Access Compliance Report

Public Rights-of-Way

(Curb Ramps)

Intersection ID: 28076	Main Street: ALEXANDER MARTIN AV	Cross Street: REA RD	Location: NE
ADA ID: 01C106843524	Ramp Type: Perp	Initial Pass/Fail: Fail	Overall Compliance: No
Codes/Mitigation Info/Possible Solution		Field Measurements/Component Compliance	
Severity Score: 21.25

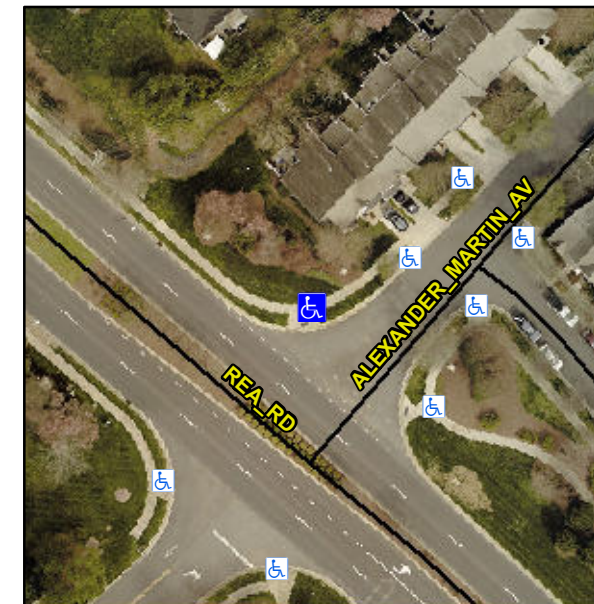
Not Found, R304.5.1, R304.2.2

Compliance	Description	Data	Compliance	Description	Data
N/A	Ramp Length (in)	144.0	No	Ramp Slope (%)	8.9
No	Ramp Width (in)	47.0	Yes	Ramp XSlope (%)	1.3
N/A	Flare Type LT	N/A	N/A	Flare Type RT	N/A
N/A	Flare Slope LT (%)	N/A	N/A	Flare Slope RT (%)	N/A
N/A	Flare Traversable LT?	N/A	N/A	Flare Traversable RT?	N/A
N/A	Landing Length (in)	N/A	N/A	DWS Provided?	N/A
N/A	Landing Width (in)	N/A	N/A	DWS Contrast?	N/A
N/A	Landing Slope (%)	N/A	N/A	DWS Length (in)	N/A
N/A	Landing X Slope (%)	N/A	N/A	DWS Full Width?	N/A
N/A	Landing Curb? (Y/N)	N/A	N/A	DWS Offset (in)	N/A
N/A	Shared Landing?	N/A			
N/A	Gutter Ponding?	N/A	N/A	Gutter Slope (%)	N/A
N/A	Gutter Lip Ht (in)	N/A	N/A	Gutter X Slope (%)	N/A
N/A	Painted X Walk1?	No	N/A	Painted X Walk2?	N/A
	X Walk 1 Direction	To SE		X Walk 2 Direction	N/A
N/A	X Walk 1 Width (in)	N/A	N/A	X Walk 2 Width (in)	N/A
	X Walk 1 Slope (%)	2.7		X Walk 2 Slope (%)	N/A
	X Walk 1 X Slope (%)	0.5		X Walk 2 X Slope (%)	N/A

Remove & Replace Entire Ramp.
